Appendix B
NOP and Scoping Materials

SUBJECT: Notice of Preparation (Notice) of a Program Environmental Impact Report for the Altamont Pass Wind Resource Area (APWRA) revisions to Conditional Use Permits (CUPs) for repowering and continued maintenance and operation of wind turbines in Alameda County

Re: Altamont Pass Wind Resource Area Revised Conditional Use Permits
SCH# 2010082063

Figure 1

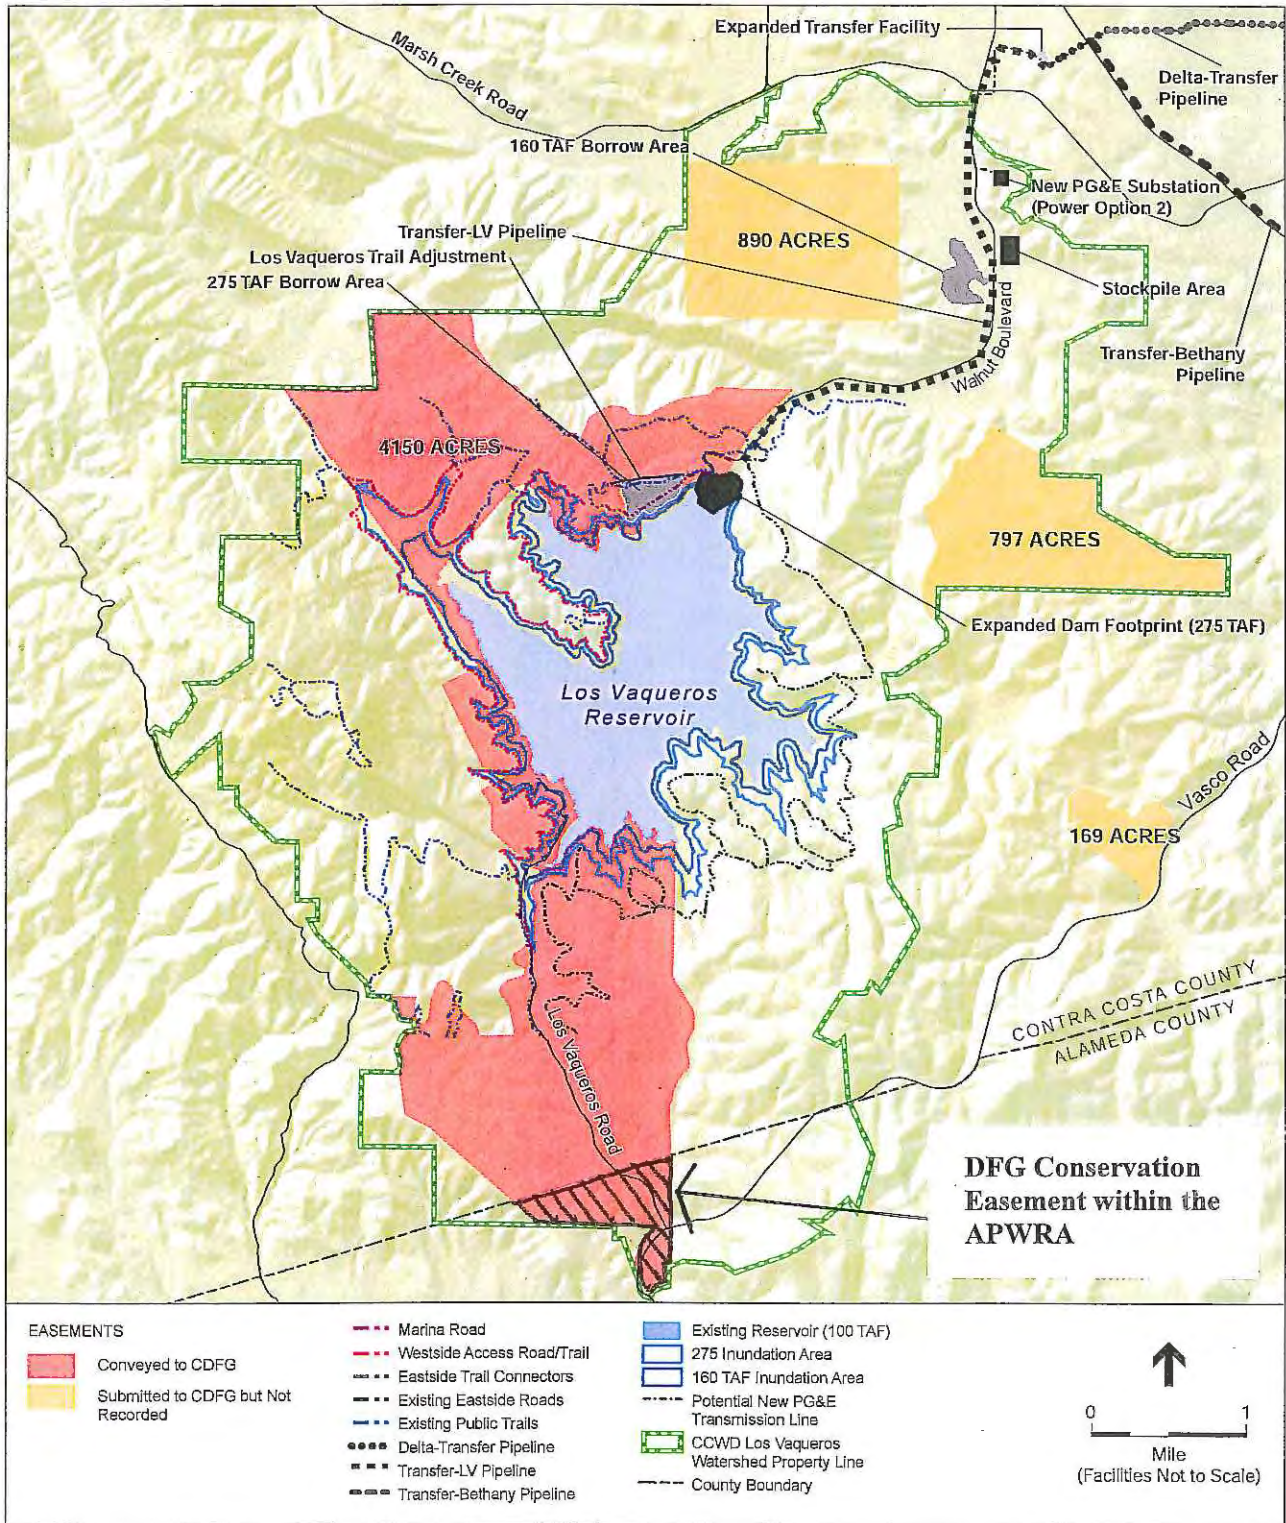
A portion of the APWRA Conservation Plan area and CUP Permit area is within Los Vaqueros Watershed property owned by CCWD within Alameda County (see Figure 1, attached). CCWD recorded a conservation easement in favor of the California Department of Fish and Game (DFG) on September 8, 1994 for the protection of the San Joaquin Kit Fox and other wildlife species (Conservation Easement) and a portion of this easement area is within the APWRA. The shaded area within Figure 1 illustrates the Conservation Easement area that has been conveyed to the DFG by CCWD within Alameda and Contra Costa Counties.
